RHODE ISLAND DEPARTMENT OF ENVIRONMENTAL MANAGEMENT RESPONSE TO U S
NAVY COMMENTS TO DRAFT FINAL SUPPLEMENTAL REMEDIAL INVESTIGATION SITE 8
WITH TRANSMITTAL NS NEWPORT RI

Re: Draft Final Supplemental Remedial Investigation
Site 08, NUSC Disposal Area
Naval Station Newport, Newport, Rhode Island

RIDEM's Responses to Navy Responses (dated July 13, 2011)
to RIDEM Comments (dated June 16, 2011)
on the Draft Final Supplemental Remedial Investigation (dated May 13, 2011) for
Site 08 – Naval Undersea Systems Center (NUSC) Disposal Area
Naval Station Newport, Newport, Rhode Island

FIGURE 1-6

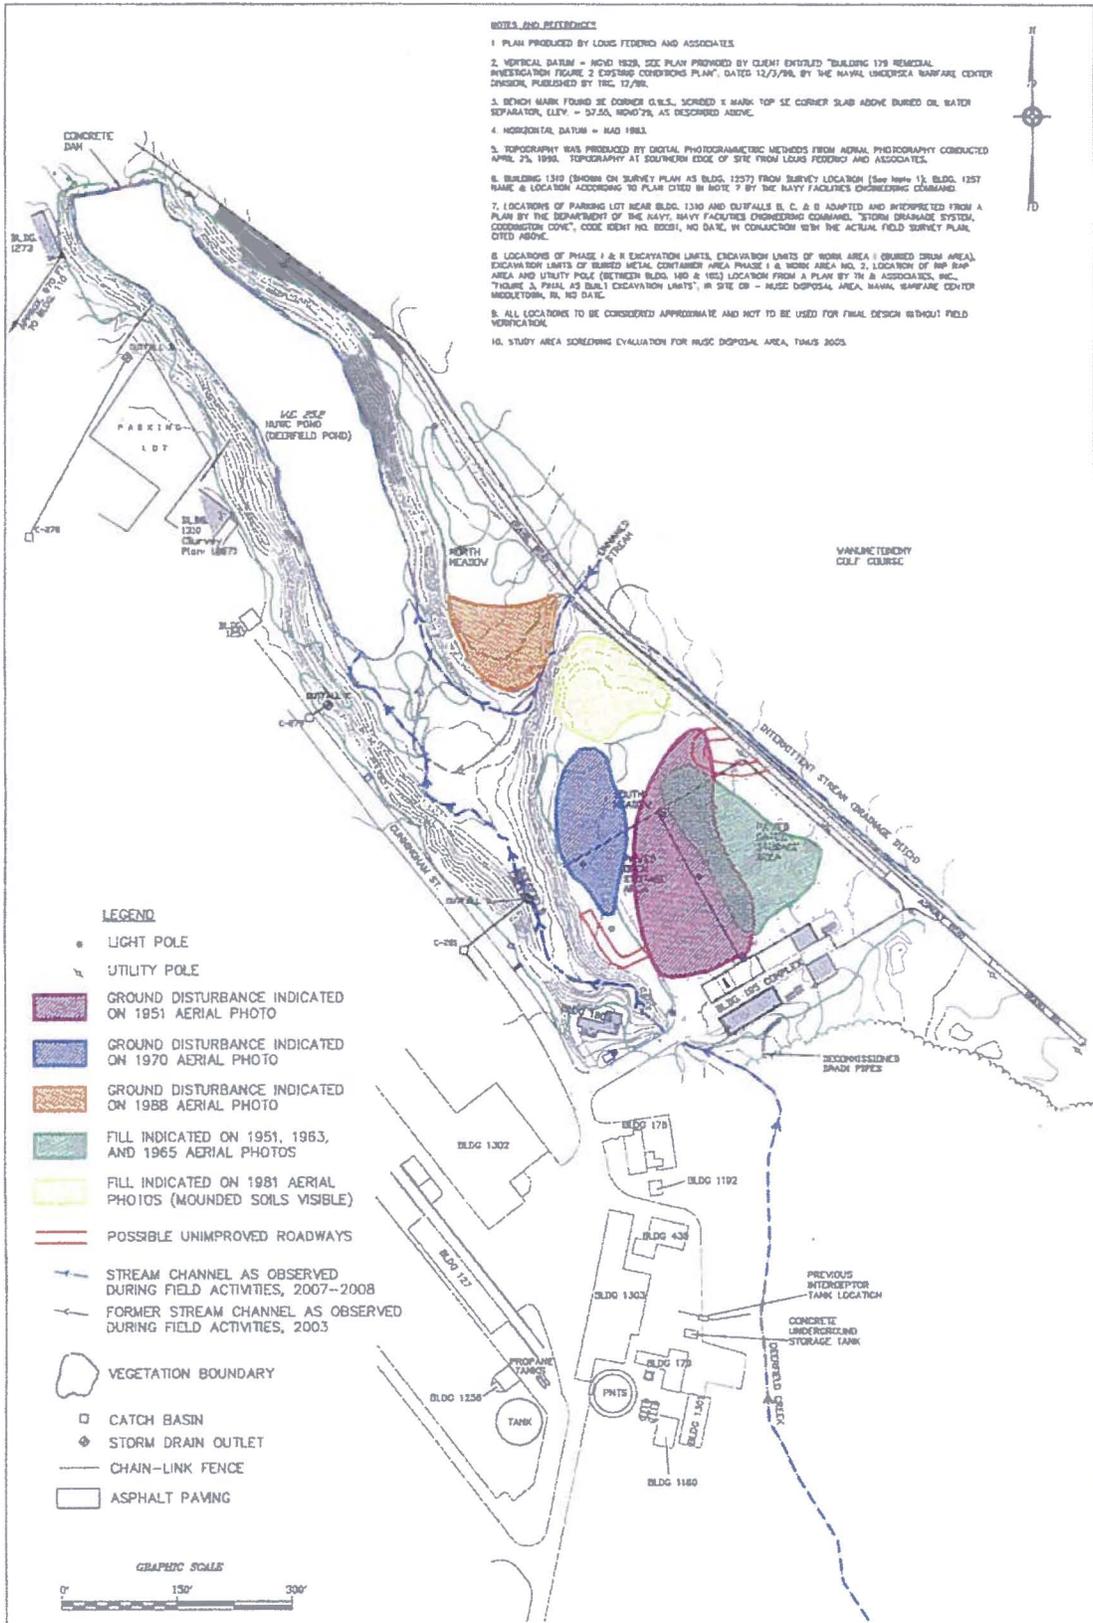
In regards to the soil type, please refer to the attached Figure 1-6 from the NUSC RI of the fill areas determined from aerial photos. RIDEM does not agree with classification of the soil as type Se for the

majority of the Site since much of this area contains fill material. Please be advised that RIDEM, to date, has not accepted the "Basewide Background Study Report". Levels of arsenic in the 30-40 mg/kg range are not acceptable background levels.
